# Global Programme to Support Countries with the Shift to Electric Mobility - Addendum

**Review PIF and Make a recommendation**

10544

PFD

Fig. 3. GHG emissions due to the use of electric vehicles in the European Union.

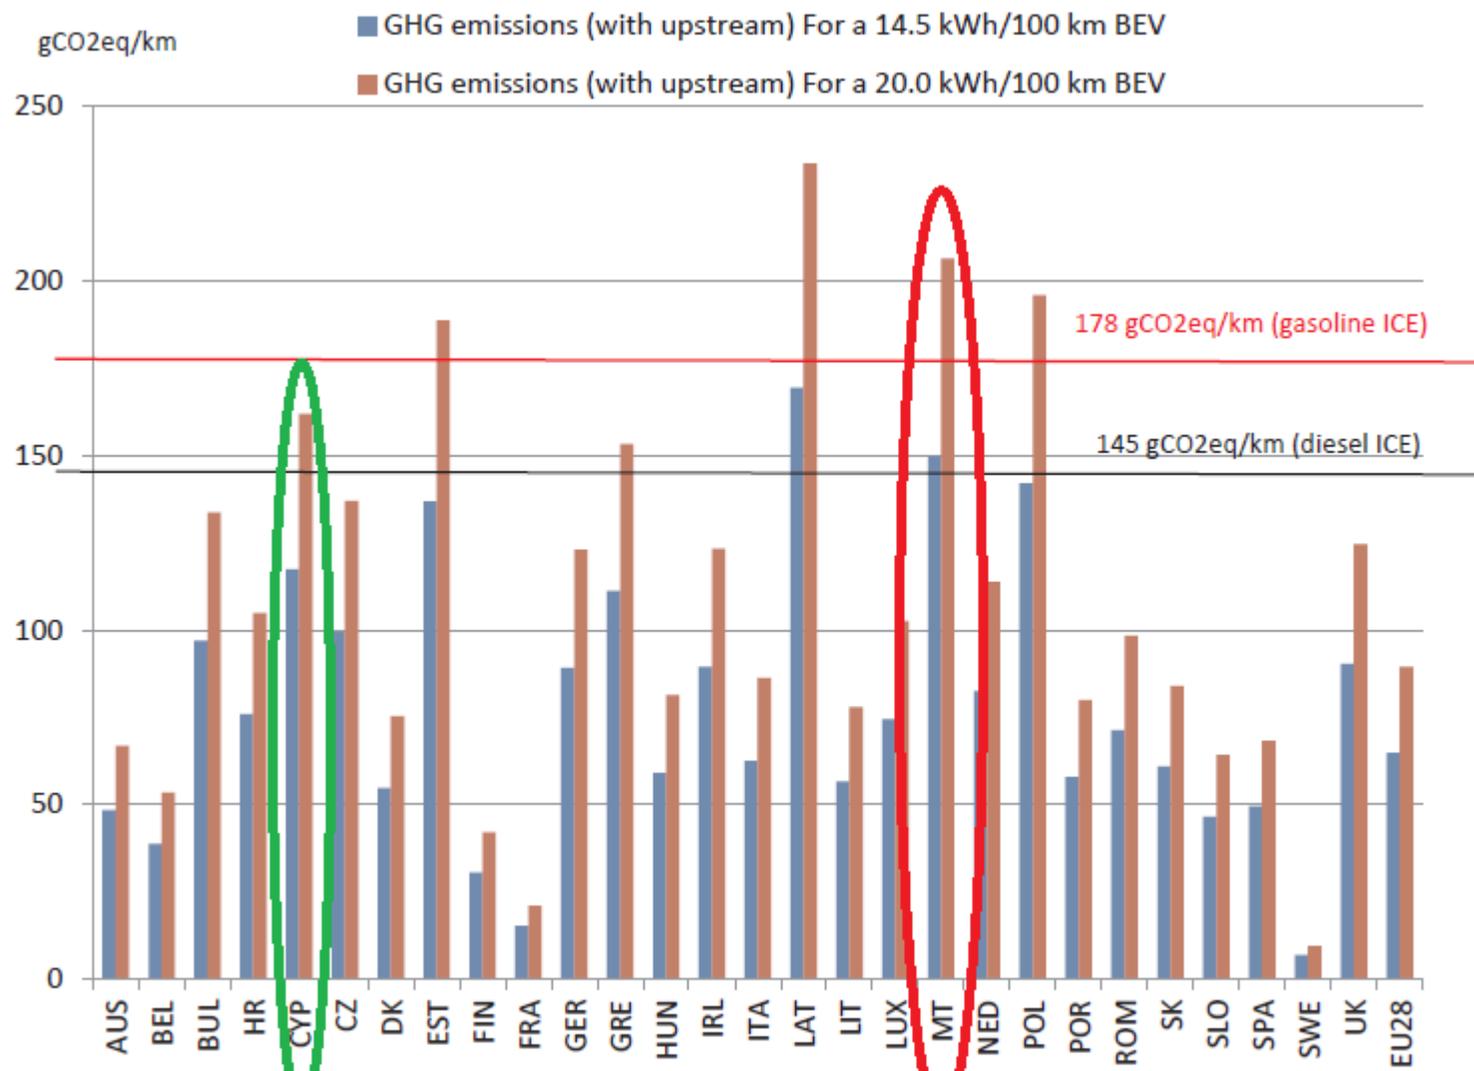
1. PPG grant is above the cap. Either provide justification including break down of costs (GEFSEC will reserve the right to approve or not the exception to the policy).
2. The co-financing from DBSA is missing. According to discussions with DBSA, there should be investment mobilized from DBSA of approximately USD 100million in loans to leverage the GEF resources.
3. With regards to this sentence on page 68:

This intended change in carbon intensity of grid electricity is essential for any electric mobility project in South Africa, since the carbon intensity of today's grid power leads to increased GHG emissions from an electric vehicle compared to a conventional one. In 2015, the transport sector accounted for about 13% of energy related CO<sub>2</sub> emissions, with road transport being responsible for more than 90% of all transport emissions (Figure 2).

It is generally recognized that even in high carbon intensity grid countries, EV are more efficient than ICE in terms of emissions per kilometers. Please include a reference/additional info for this sentence or remove it.

Along the same lines goes the following statement:

Since South Africa has one of the highest grid electricity carbon footprint worldwide, in the near future significant CO<sub>2</sub> emission reductions can only be achieved if the carbon footprint of the electricity used to charge the buses is at least 30% lower than the average grid. This is why the demonstration projects will seek for ways to use lower carbon footprint electricity for example based on agreements with renewable power producers to buy their electricity either for direct use to charge the e-buses, or by off-setting emissions elsewhere in the grid.

Please confirm if there is available literature that has established that ICEs have less emissions than EVs powered with SA grid electricity?

3. The statement has been removed.

Recognizing that additional renewable energy needs to be included in South Africa to reduce emissions with the introduction of electric vehicles, the South African project aims at including a 30% renewable energy share in the electricity mix used for charging the demonstration buses. As shown in Figure 1 of the South Africa concept note, under all scenarios (IRP2 to IRP4) tested in the South African Integrated Resources Plan (2018), the share of coal in the power mix will be reduced by approximately 50% (from currently 81% of the total electricity production to around 40%) by 2040. The reduction in coal-based power production will be replaced almost entirely by renewable energies (wind, solar PV, CSP and hydro). This gradual increase in the share of renewable power generation in the South Africa's energy mix will therefore contribute to the reduced CO<sub>2</sub> emissions stemming from the electric vehicles – and this was also considered when estimating the GHG emission reductions for the South Africa e-mobility proposal. Please also refer to our responses to comment No. 3 in the section 6. of the review sheet dedicated to “contributions to global environmental benefits” further down.

Please also see analysis from EU JRC on EV emission mitigation within various EU grids (Electricity carbon intensity in European Member States: Impacts on GHG emissions of electric vehicles, Alberto Moro, Laura Lonza European Commission, Joint Research Centre (JRC), Via Enrico Fermi 2749, 21027 Ispra (VA), Italy, <https://www.sciencedirect.com/science/article/pii/S1361920916307933> ). Data from Cyprus and Malta, which respectively have similar grid emission factors to Indonesia and South Africa, respectively, show the impact of the grid emission difference on GHG emission savings from EVs.

In any case, both the Indonesia as well as the South Africa Child Project take into account the further integration of renewable power for EV charging to generate substantial GHG emission reductions.
